**Attachment A
AOS Response to RAI's
Dated 12/24/09**

**Docket 71-9316
TAC No. L24353**

AOS Response to RAIs Dated 12/24/09 (TAC # L24353)

Figure 1. Axisymmetric Head-On Impact Load Distribution

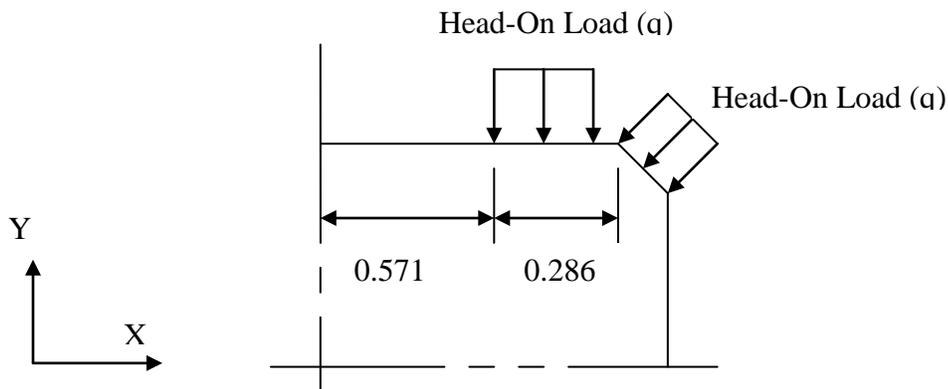
2.22 *Provide the numerical values for loads P (total impact force) and Q (pressure load) in the equation used on page No. 2-136 of the application (Section No. 2.7 “Hypothetical Accident Conditions of Transport”) to compute the load intensity in the 2-D cask model.*

Loads applied in the 30 ft accidental drop analyses are listed in the detailed description of the 30-drop analyses given in Paragraph 2.7.1.5.2.1. The head-on impact load distribution is axisymmetric, as shown in Figure 1. The applied traction, q , is given by the total impact force, P , divided by the impacted surface area, A .

$$q = P/A$$

In the Libra program q is entered on a LE -4 records.

Figure 1. Head-On Drop Cask Model

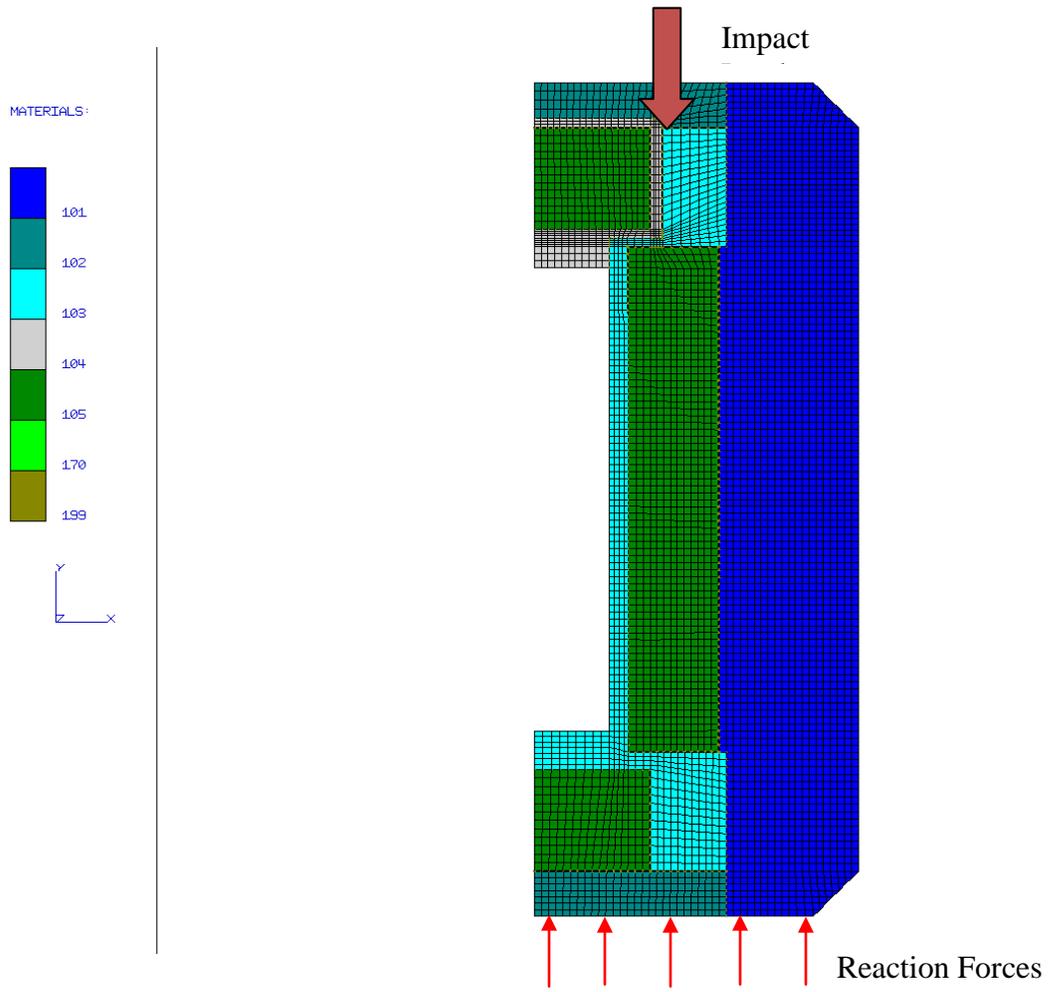
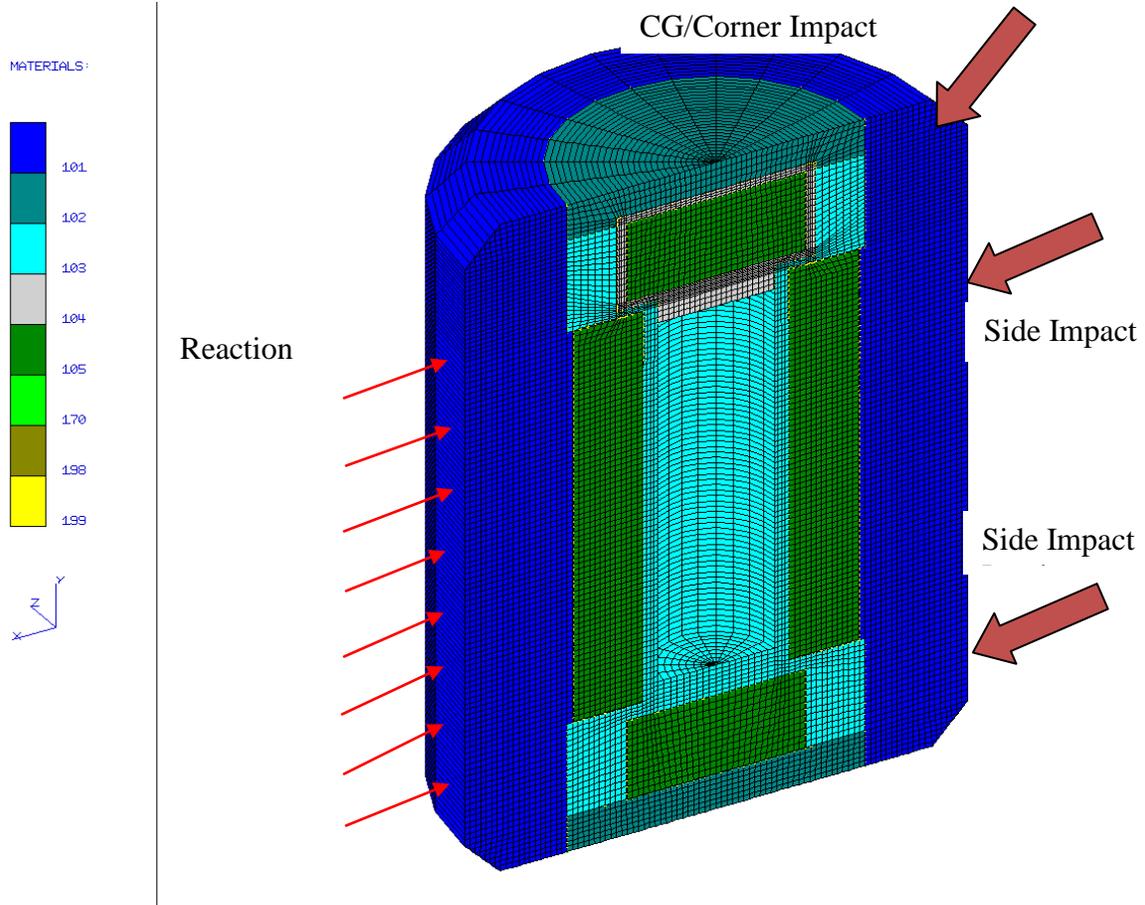
2.23 Describe the form that the inertia body force takes. Section No. 2.7.1.1.2 (page No. 2-136) of the application states that "In addition to the impact load, an opposing inertia body force is applied to the cask. Displacements are fixed along the cask base to account for non-equilibrium of pressure and inertia forces." Provide the magnitude of this force. Show where the fixed nodes are located and list the magnitude(s) of the force(s) at each node.

The following discussion references Table 1 and Table 2, as well as Figure 1 and 2 below. These tables and figures are duplicates of Paragraph 2.7.1.5.2.1 for the model AOS-100, and are presented here for clarity. Impact loads determined in the drop analyses and applied in cask stress analyses are summarized in Tables 1 and 2 given below. Table 1 presents impact loads found in the over-pack drop analyses. Table 2 presents actual loads applied in the cask stress analyses. The actual applied loads, P', in Table 2, should equal or exceed the loads P in Table 1. Explanations of all factors in Table 1 are given in Paragraph 2.7.1.5.2.1. An inertial acceleration, A' in Table 2, is applied in the cask stress analyses in addition to the impact load, P'. The inertial acceleration forces react the impact load and prevent large support loads, while having only a marginal affect on local stress values. The accelerations A' are listed in the second table, and are based on the actual impact load and the weight of the stress model, M, also given in Table 2.

R - total reaction force from FEM cask analysis, $R = P' - A' \cdot M$

The fixed nodes where the reaction forces are located are shown schematically on Figures 1 and 2.

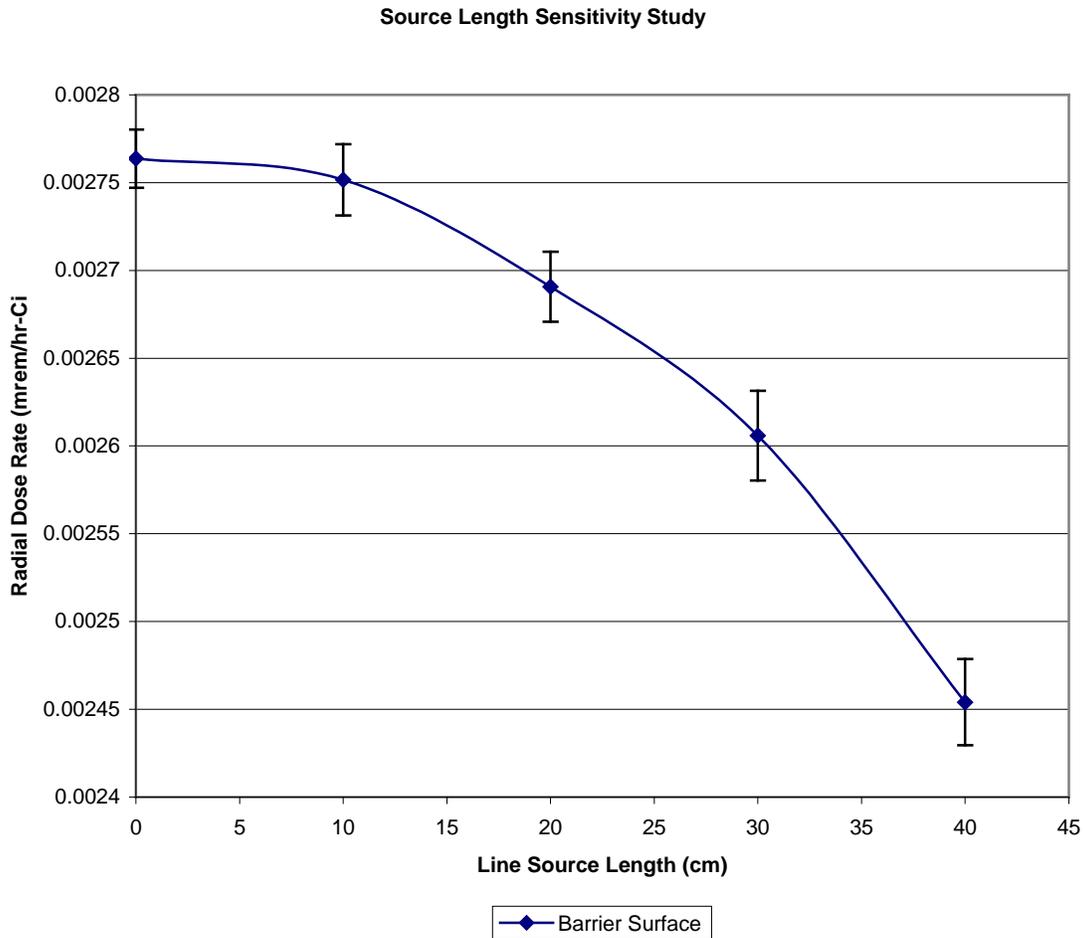
5.3 *Provide additional information to justify the use of the point source approximation.*

In cases where the true source geometry is long enough that it might be better represented by a line source, the error associated with the use of a point source may be large, but it will always be in the conservative direction. This general trend is demonstrated in the supplemental information provided by the review team, including the following websites:
